STAFF REPORT and TENTATIVE DECISION

Item: MLP 2021-005
Minor Land Partition

PRELIMINARY PARTITION PLAT 310 RAPP ROAD

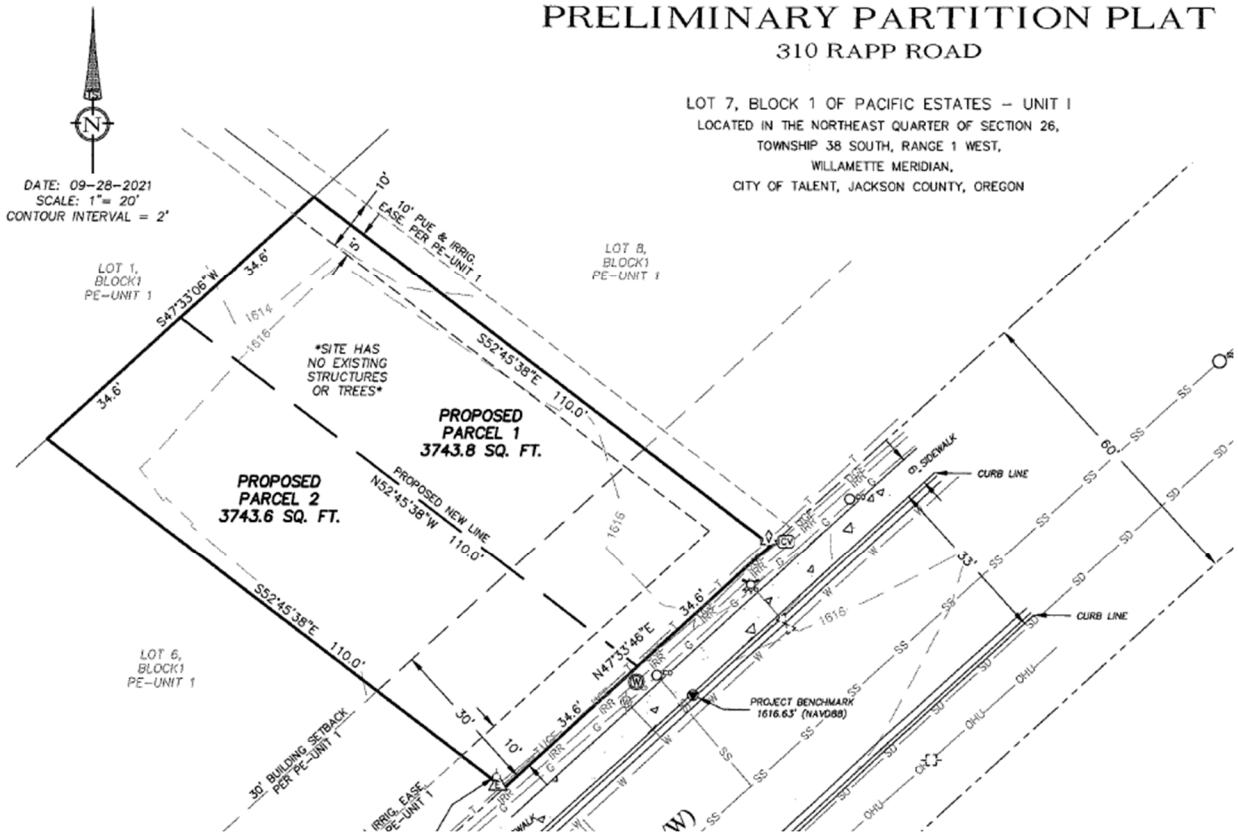
FINDING: Applicant proposes two separate driveway access aprons with 2’ separation. To meet the provisions of this section both parcels will need to share one consolidated access, per conversation with Public Works Supervisor on November 29, 2021. **The provisions of this section can be met subject to conditions of approval.**

FINDING: Applicant proposes individual driveway aprons for the future development of these two parcels. However, per 17.10.060(G), both parcels will need to have a single access ramp that meets the minimum driveway width per 17.10.060(F). A reciprocal easement will not be required under this configuration. **The provisions of this section have been met.**

4. The property owner(s) shall obtain an encroachment permit if new access is proposed or existing access is modified. Curb, gutter and sidewalk modifications are to be built to City standards.
5. Provide one consolidated access ramp for parcel 1 and parcel 2, per 17.10.060(J).
6. (RVSS) The property owner of Parcel 1 and Parcel 2 shall:
 - a. Obtain a sewer tap permit from RVSS and pay all related fees.
 - b. Prepare a stormwater management plan in accordance with the Regional Stormwater Quality Design Manual as applicable.
 - c. Applicant must record a Declaration of Covenants for all new stormwater quality features.
 - d. Construct sewer facilities per RVSS standards
 - e. All new sewer facilities must be, inspected, and accepted per RVSS standards.
 - f. Applicant must have all stormwater quality facilities, including vegetation when applicable, inspected and approved by RVSS.
